KNODEL SUBDIVISION, RESUBDIVISION OF LOTS 1-3

Engineering Comments: FINAL PLAT COMMENTS (should be addressed prior to submitting the FINAL PLAT for acceptance and signature by the City Engineer):

APPLICATION NUMBER 3 DATE July 16, 2020

DETAIL SITE PLAN

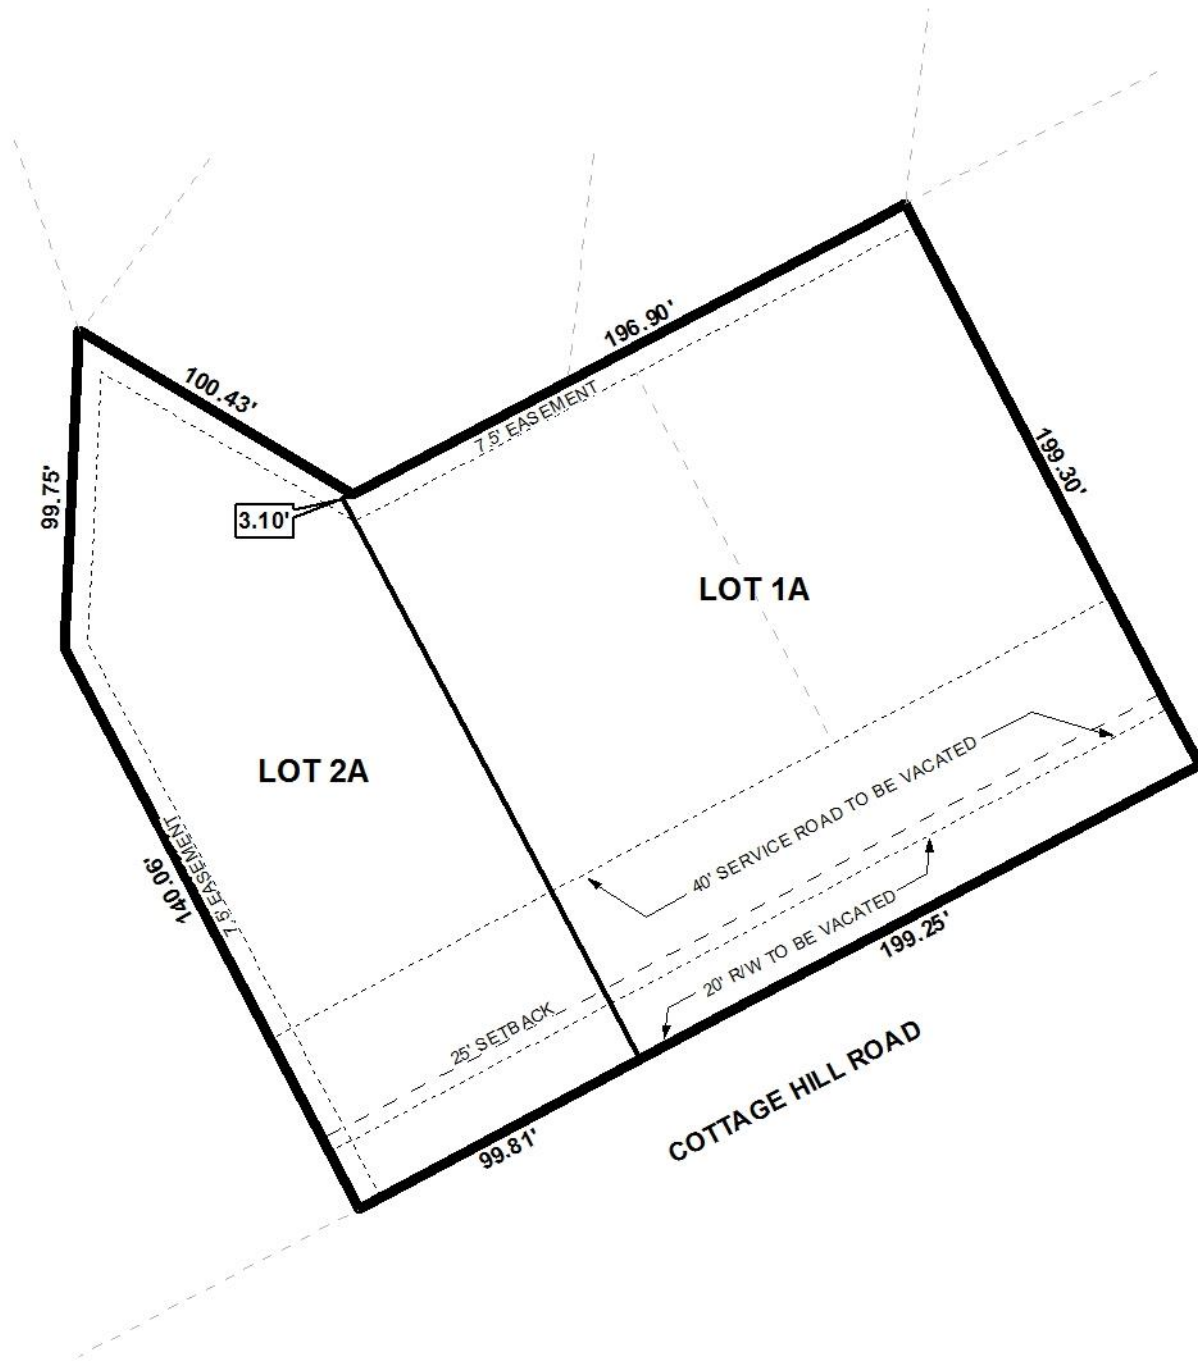
- B. Provide the recording information for the proposed ROW Vacation.
- C. Show and label the width of Cottage Hill Rd ROW to verify that it contains the required minimum width after the ROW Vacation is approved.

- D. Show and label all flood zones. New maps went into effect on June 5, 2020.
- E. Show and label the MFFE (Minimum Finished Floor Elevation) on each lot that contains an AE, V, or X (shaded) flood zone designation.

- F. Check NOTE #11. It appears to be a copy of Notes #7 & #8.
- G. Provide the Surveyor's and Owner's (notarized) signatures.
- H. Add a note to the SUBDIVISION PLAT stating that as shown on the 1984 aerial photo (FLIGHT 21 - #81) LOTS 1A and 2A will receive historical credit of existing (1984) impervious area towards stormwater detention requirement per Mobile City Code, Chapter 17, Storm Water Management and Flood Control) as follows: LOT 1A – NONE, LOT 2A – 5,500 sf.

The proposed lots both have frontage on Cottage Hill Road, a major street. The preliminary plat labels the Cottage Hill right-of-way as “varies” however per the Major Street Plan this portion of Cottage Hill Road requires a 100’ right of way. It is important to note that the proposed subdivision includes a request to include 60’ of previously dedicated right-of-way which would be incorporated back into the proposed lots. According to City records, the 60’ in question was dedicated to the City as part of the original Knodel Subdivision approved in 1972. At the time of the original subdivision the City planned to build a service road along Cottage Hill, however the road was never constructed and the Major Street Plan has since been amended to not require service roads. As such, vacating some portion of the 60’ may be appropriate, but would require approval of the vacation process through the City Clerk’s office prior to the signing of a Final Plat, if approved. Additionally, the applicant should note that the current 100’ right-of-way would still be required, and as such should be revised on the Final Plat to illustrate 50’ from the centerline of Cottage Hill Road.

The preliminary plat does illustrate a compliant 25’ minimum building setback along the frontages of the proposed lots and should be retained on the Final Plat, adjusted for any approved vacated right-of-way.

In accordance with the Subdivision Regulations, it appears that the proposed lots will exceed the minimum lot size requirement with or without the requested vacated right-of-way. However, the preliminary plat does not include the square footage data for either proposed lot, as such if approved, the Final Plat should be revised to include the lot size labels in both square feet and acres or a table should be furnished on providing the same information, adjusting for the amount of vacated right-of-way approved.

As a means of access management, a note containing the Traffic Engineering comments should be placed on the Final Plat. Additionally, as easements are recorded on the subject property they should be indicated and labeled on the Final Plat, and a note should be placed on the Final Plat stating that no structures shall be constructed or placed within any easement.

- 1) completion of the right-of-way vacation process through the office of the City Clerk prior to signing of the Final Plat;

- 2) revision of the Final Plat to reflect the approved vacated right-of-way, adjusting the minimum building setback line to account for the shift in the front property line;

- 3) revision of the Final Plat to illustrate provision of 50' from the centerline of Cottage Hill Road and label the width of right-of-way;
- 4) revision of the Final Plat to include the lot size labels in both square feet and acres, adjusting for the amount of vacated right-of-way approved, or a table should be furnished on the Final Plat providing the same information;

- 5) retention of all easements recorded on the subject property and the placement of a note on the Final Plat stating that no structure may be placed or constructed within any easement;
